Strengthening of connecting lap of forked airbrake push rod in fuselage.

LTA Nr. 7/62

Leistungseinsitzer
Schleicher Ka 6
Bearb. R. Kaiser 13.9.62.

Zeichnung zu
Änderung Nr. 7

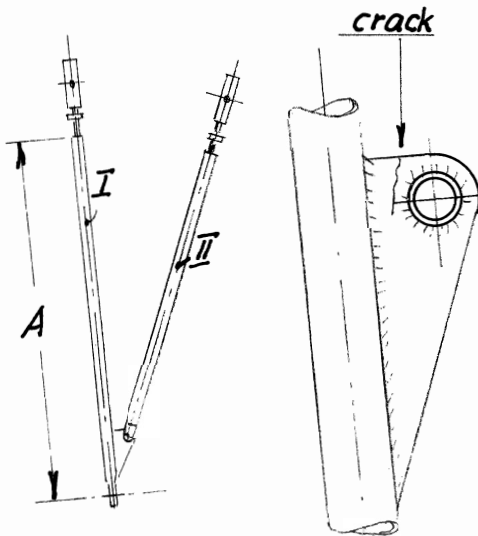
There have been found cracks on several pieces as shown in figure.

Urgency: If a crack is found immediately; by repairs; all other gliders until the next annual inspection.

- 1.) The pushrod I) is to be build out and replaced by a modified one. Secure all screws and pins by split pins properly. The quick - connecting head is to be adjusted at the assembled glider and secured by the nut. Check proper closing of both airbrakes!
- 2.) The modified pushrod is to be ordered by the Firma of A. Schleicher or one of the License firma. The distance A) must be given exactly when ordering.

- 3.) The modification is made from S.No. 6067 incl. 0.04"
The ~~modification~~ modified push rod has 2 plates 1,0 mm thick. A few samples are modified with 1.5 mm thick plates, this is taken as equivalent.
a. 0.06"

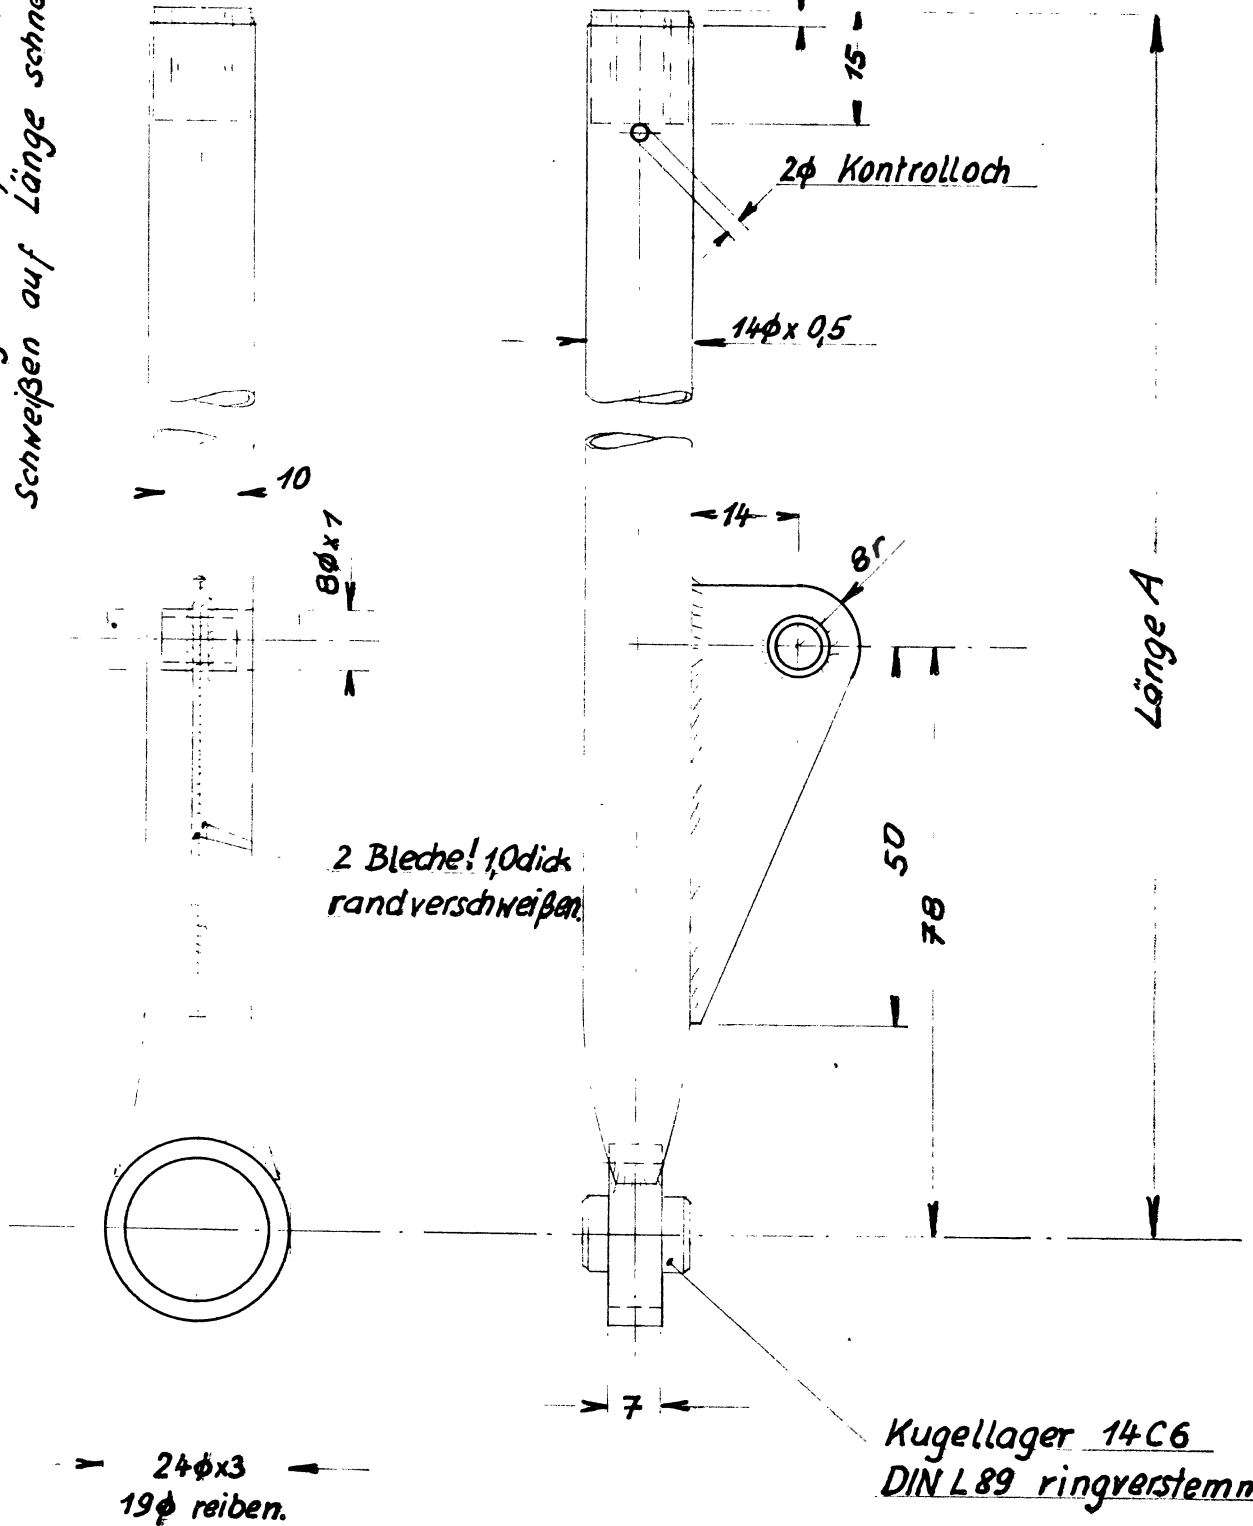
Drawing to be corrected: 8	Remarks			PFL Check
Drawing to modification Nr. 7 (Normally not given to aircraft owners)	ausgef.	13.9.62.	Kaiser	 <i>Reinhe</i> 5. Okt. 1962

Rohr länger lassen, nach dem
Schweißen auf Länge schneiden.

M8 zunderfrei. Erst schweißen, dann
schneiden

Kugellager 14C6
DIN L 89 ringverstemmt

Werkstoff:
Stahlrohr St. 35, 29
Stahlblech Fl. W. 1604
od. 1.72-14.4
